From: Scala, Mary Joy
Sent: Monday, December 28, 2015 1:07 PM
To: Charlie Armstrong (CharlesA@southern-development.com)
Cc: Kevin Lewis (klewis@TheBCGroup.com); Andrew Garlock (agarlock@TheBCGroup.com)
Subject: BAR Action – December 15, 2015 – NW Corner of Ridge and Cherry

RE: Certificate of Appropriateness Application
BAR 15-08-04
NW Corner of Ridge and Cherry
Tax Parcel 290145000-147000, 290149000-151000, 290157000
Cherry Avenue Investments LLC, Owner and Applicant
Proposal for a new Marriot Hotel on Cherry and Ridge (final details)

**CITY OF CHARLOTTESVILLE
BOARD OF ARCHITECTURAL REVIEW
STAFF REPORT
December 15, 2015**

Proposed new construction of a Marriot Hotel (final details)

FINAL SITE DEVELOPMENT PLAN FOR
WILLIAM TAYLOR PLAZA PUD (PH1)
CITY OF CHARLOTTESVILLE, VIRGINIA
SHEET TITLE: LANDSCAPE PLAN

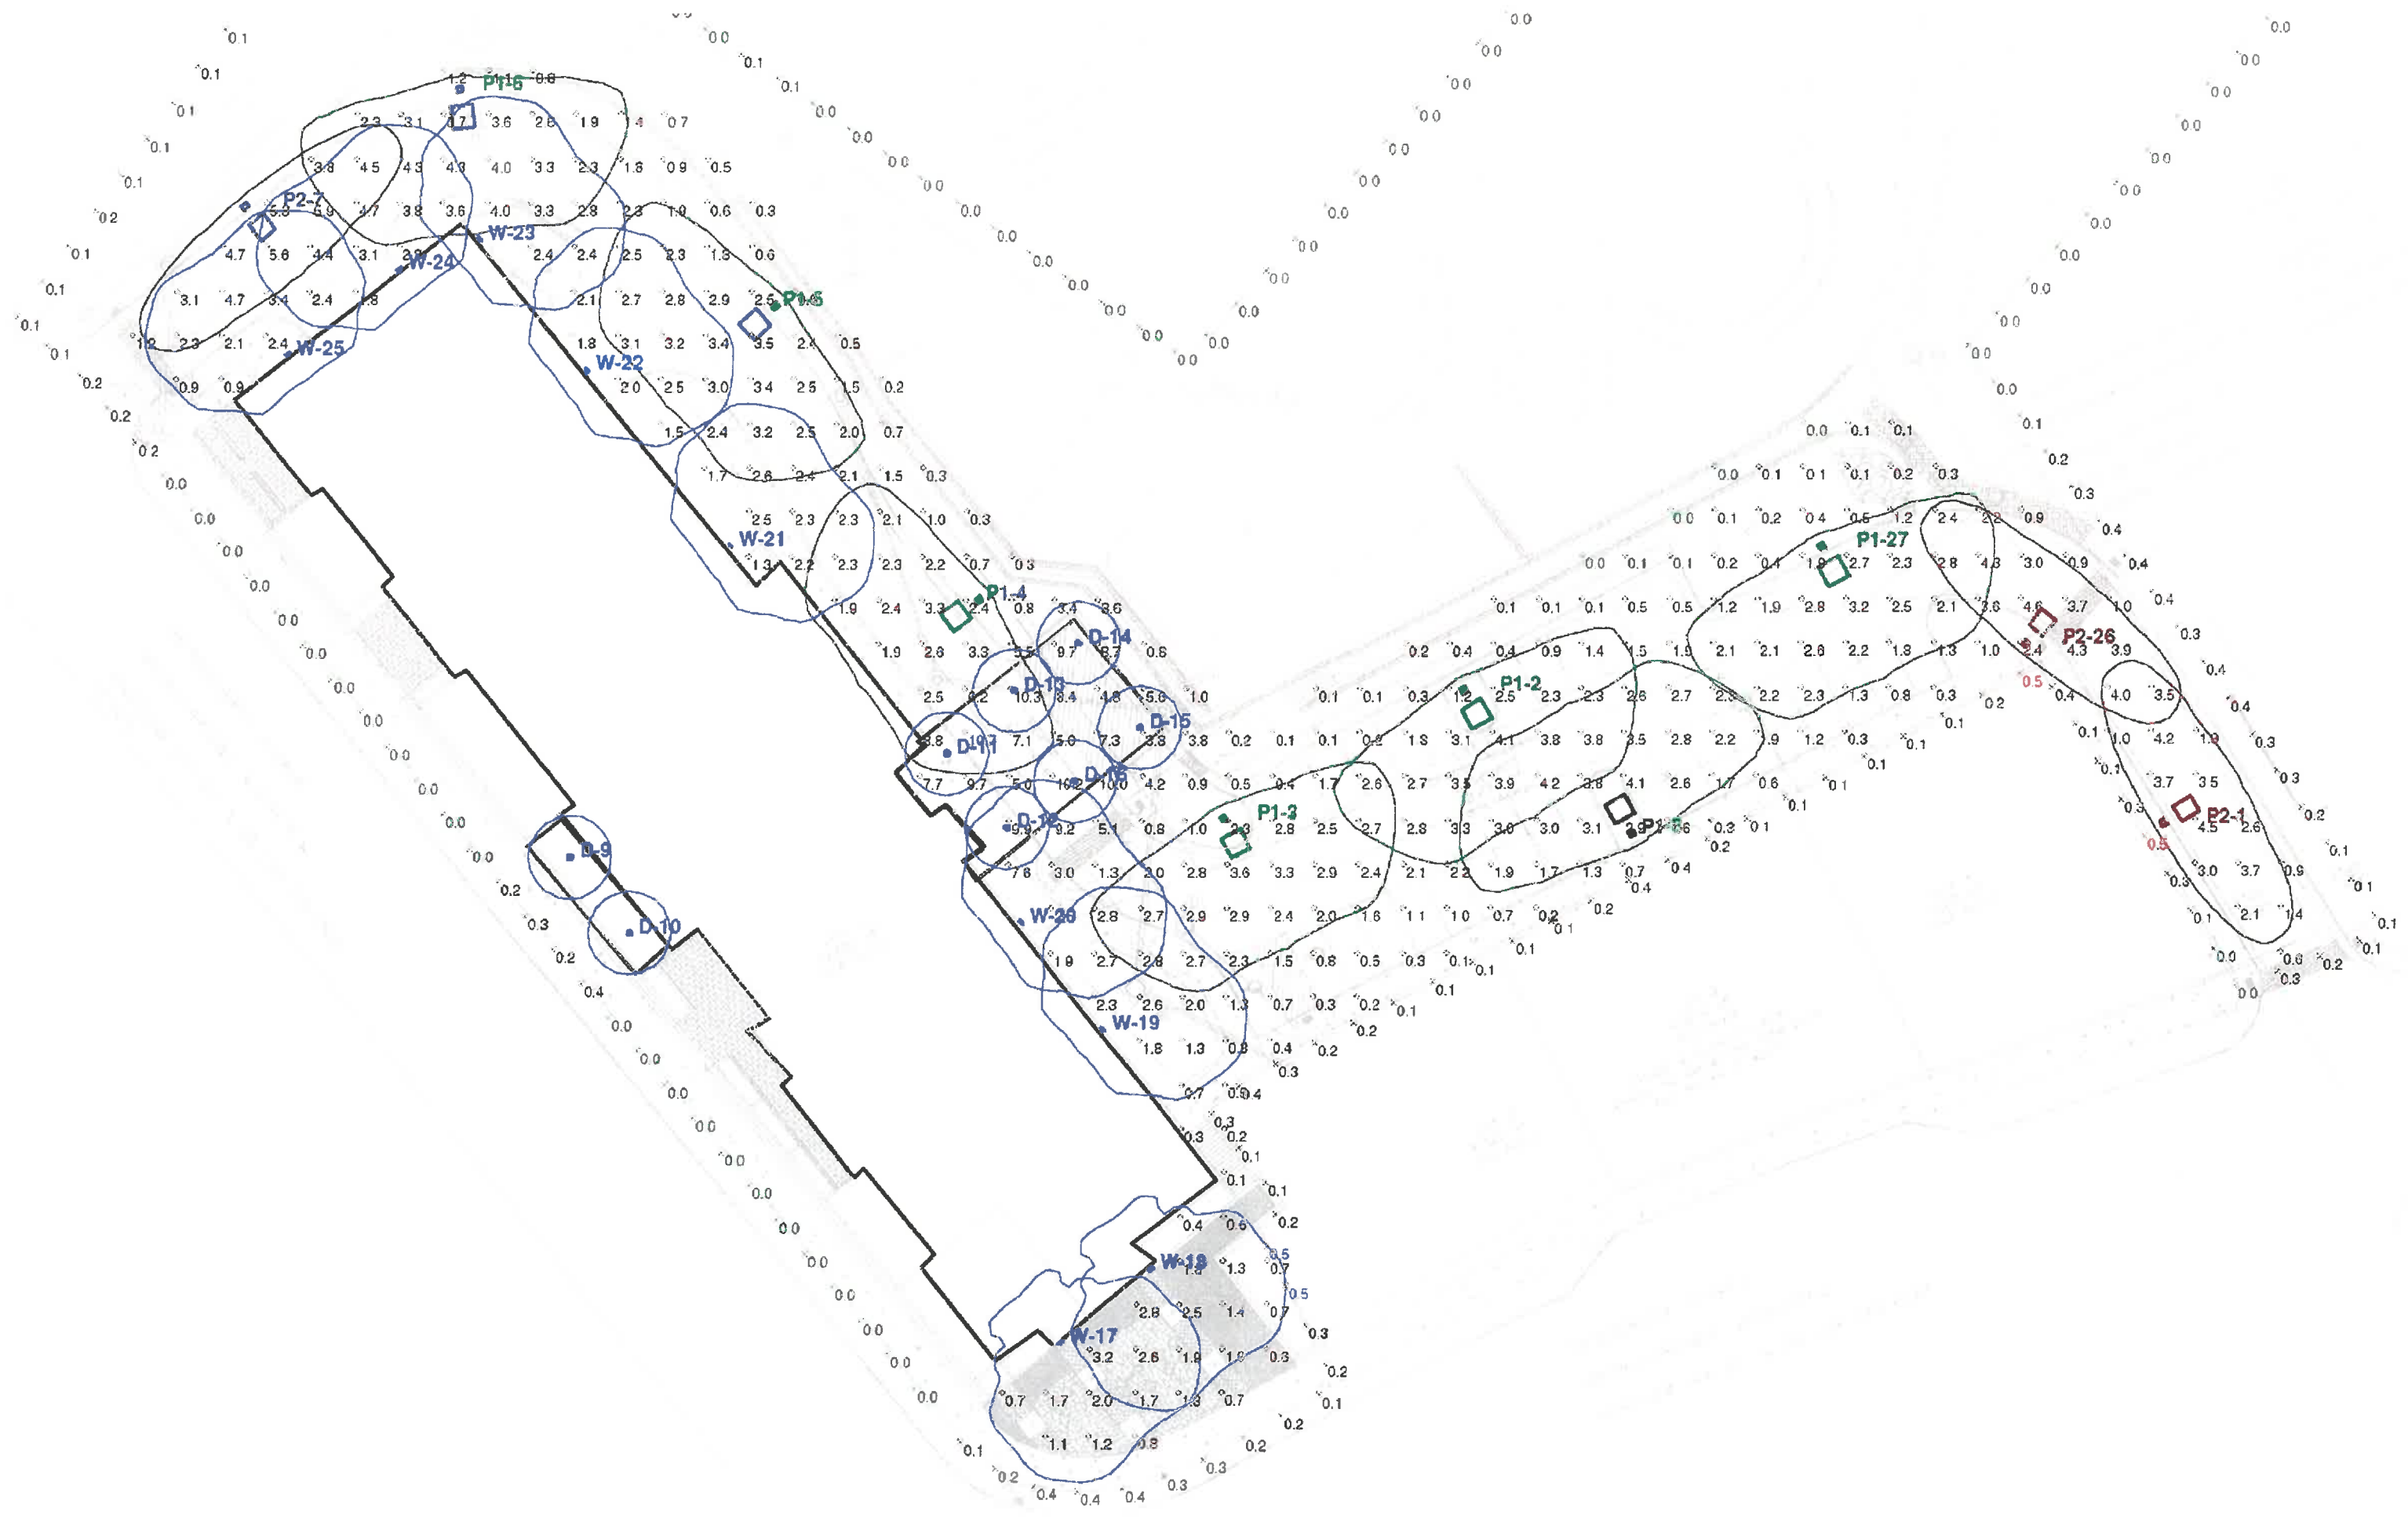
- **eliminate the sidewalk colored pavers and floating seat wall from the plaza;**
- **change Redbuds on plaza back to Red Maples;**
- **raise the canopy on the plaza side, and continue to refine, submitting any changes via email;**
- **institute lighting controls;**
- **replace upright shrubs on retaining walls with leafing or draping ones; and**
- **replace the Japanese Beauty Berry with the American Beauty Berry.**

- The plaza was redesigned to be open to the corner, signifying a more public space. The large brick planters previously proposed have been replaced with trees and tree grates. The trees were arranged as to create an outdoor “ceiling” effect for the user at the seating areas of the plaza. We are proposing 3 separate paver patterns/colors to signify separate spaces within the plaza. The linear concrete pavers are used in circulation spaces, the dark 8x16 pavers are used as accent strips (generated from lines pulled from the building façade), and the tan random paver pattern signifies the “assembly” or sitting space. Solar LED bike lockable bollards were added to the plaza design. These bollards provide a vehicle impact rated perimeter barrier around the plaza, provide LED downlighting during the night for safety, and also provide a means for locking up bikes.
